**MC68440 RS8 Mask
Errata Sheet
November, 1984**

The following is an explanation of three problems that exist on the current mask set (RS8) version of the MC68440 Dual Direct Memory Access Controller (DDMA). This mask set is available under the part number SC87876.

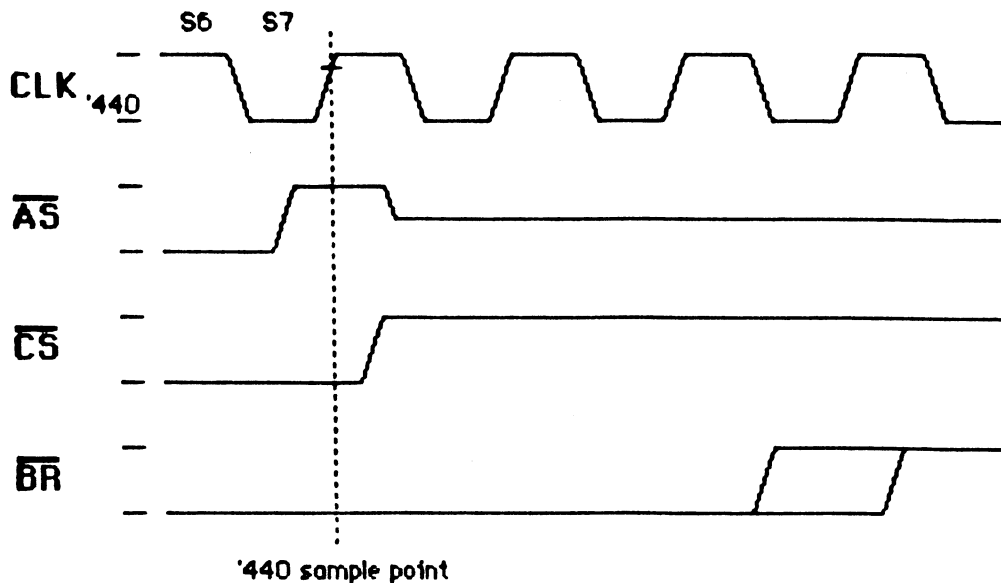
If the DDMA is being accessed in the MPU mode (either during a chip select or an interrupt acknowledge), is simultaneously requesting and has been granted the bus, and the negation of \overline{CS} or \overline{TACK} is delayed from the negation of \overline{AS} , then the channel that is causing the bus request may be aborted erroneously with an address error exception flagged in the corresponding Channel Status and Error Registers.

The signal timing that will cause this error is shown in the diagram below. The problem occurs due to the fact that the DDMA will attempt to take control of the bus as soon as it detects \overline{BG} asserted and \overline{AS} negated internally. Since \overline{CS} missed the setup time to the rising edge of the clock on which \overline{AS} negated was sampled, when the DDMA starts to service the channel that was requesting bus ownership, \overline{CS} will still be asserted internally. The DDMA reacts to this situation as though it had chip selected itself, which is defined as an Address Error for the channel being serviced.

There are several solutions to this problem that utilize the same technique; to prevent the DDMA from assuming bus mastership while \overline{CS} or \overline{IACK} is internally asserted. Some possible fixes are listed below.

- 1) Guarantee that the negation of both \overline{AS} and $\overline{CS}/\overline{IACK}$ meet the input setup time to the same rising edge of the DDMA clock; thus, when the negation of \overline{AS} and the assertion of \overline{BG} is detected internally, the internal $\overline{CS}/\overline{IACK}$ will also be negated.

- 2) Negate \overline{BG} to the DDMA while \overline{CS} or \overline{IACK} is asserted; thus forcing the DDMA to synchronize the assertion of \overline{BG} and the negation of $\overline{CS}/\overline{IACK}$ at the same time. This assumes that there will be some delay from the negation of \overline{CS} to the assertion of \overline{BG} so that the internal \overline{CS} will be negated by the time the internal \overline{BG} is asserted.

- 3) Assert the Halt bus exception code to the DDMA during \overline{CS} or \overline{IACK} cycles. This will force the DDMA to synchronize and debounce the \overline{BEC} pins before it takes control of the bus. The same effect will occur if a \overline{BEC} encoding of 5 or 6 (the undefined codes) is asserted instead of the Halt. Thus, in systems using an 'LS148 to generate the \overline{BEC} encodings, the unused 5 and 6 inputs to the 'LS148 can be tied to \overline{CS} and \overline{IACK} , respectively, for a quick and easy fix.

- 4) If an address error occurs for a channel when the MAR or DAR contains a valid address for the operation programmed into the channel, simply

clear the channel error register and restart the channel to continue the operation. This may not be feasible, since a request from a device may have been lost.

This problem will be fixed in the next mask set by forcing the DDMA to wait until \overline{AS} , \overline{CS} and \overline{TACK} are all negated before it assumes bus mastership. If any of the above fixes is implemented by external hardware, future mask versions of the DDMA will operate properly in the system.

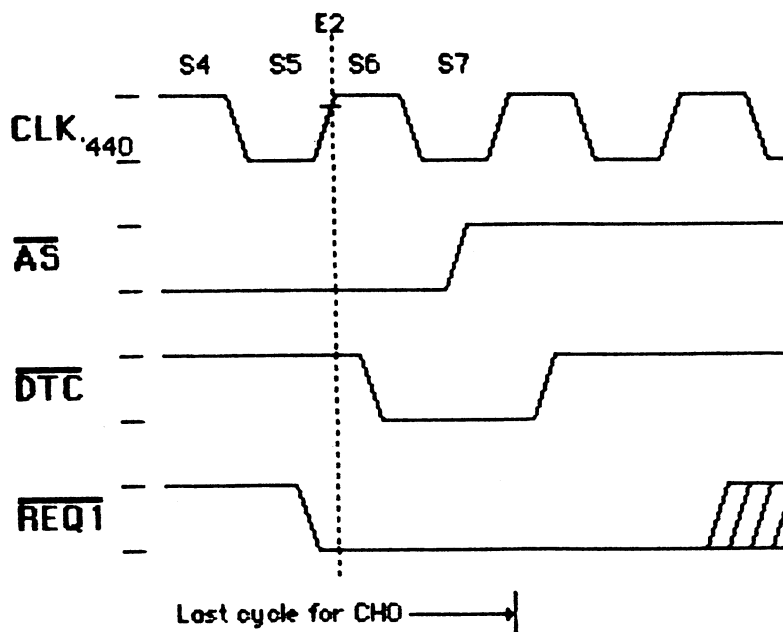
When a channel configured as shown above (subsequently referred to as the primary channel) is terminated, it is possible that it will be left in an illegal state. The illegal state will not cause an error on the primary channel since it is generated during channel termination; but it may cause an error on the other channel (subsequently referred to as the secondary channel) if a particular set of circumstances occurs.

For configuration A, the DDMA will always read two operands (bytes) from the device before writing them as a word to memory. However, if the first byte read from the device is accompanied by the assertion of \overline{DONE} by the device, the DDMA will immediately write the byte to memory and terminate the operation. Also, the MAR for the channel will be left at an odd address, which causes the channel to detect an address error that

will be ignored due to the channel termination. If an attempt were made to restart the channel without modifying the MAR, then an address error would be signalled for the channel and the operation would be aborted.

For configuration B, the MAR and DAR must both be initialized with even values, since the DDMA will perform transfers of two operands (bytes) at a time to reduce bus utilization. However, if the initial MTC value is odd, the DDMA will perform a single byte read followed by a single byte write during the last transfer. As in the configuration A case, this will leave the MAR (and the DAR) at an odd address so that an address error will be detected internally and ignored. If an attempt were made to restart the channel without reinitializing the MAR and DAR, then an address error would occur for that channel.

In addition to the occurrence of the conditions described above for the primary channel, if the secondary channel of the DDMA is configured for external request generation and has a "late" request, in either the burst or cycle steal mode, at a precise time, then improper operation will occur. In order to cause this error, a request for the secondary channel must not be detected until E2 (refer to page 4-27, figure 4-21 of the MC68440 Advanced Information Data Sheet, ADI-1002) of the last bus cycle executed to service the primary channel as shown below.

Now for a description of the actual failure mode. If either of the above sets of circumstances occurs, the secondary channel will be terminated incorrectly with an address error exception signalled in the CSR and CER. This is due to a speed path within the DDMA that causes the address error that is detected by the primary channel, but ignored, to be taken as an address error for the secondary channel. There are several possible fixes for this problem, as listed below.

- 1) Do not allow late requests on the secondary channel during the last bus cycle to service the primary channel. This is not feasible in asynchronous systems, but it points out the fact that this error will occur only if a late request occurs during the last cycle for the primary channel.
- 2) Do not use odd transfer counts, either in the device for configuration A, or in the MTC for configuration B. Again, this is not always feasible, particularly for data communications devices using asynchronous protocols.
- 3) When the secondary channel is terminated with an address error, simply clear the error and attempt to restart it. If the address error does not recur immediately, then it can be assumed that the primary channel conditions caused the address error. This method may not be feasible, since the request from the device for the secondary channel may have been lost.

This problem will be fixed in the next mask set.
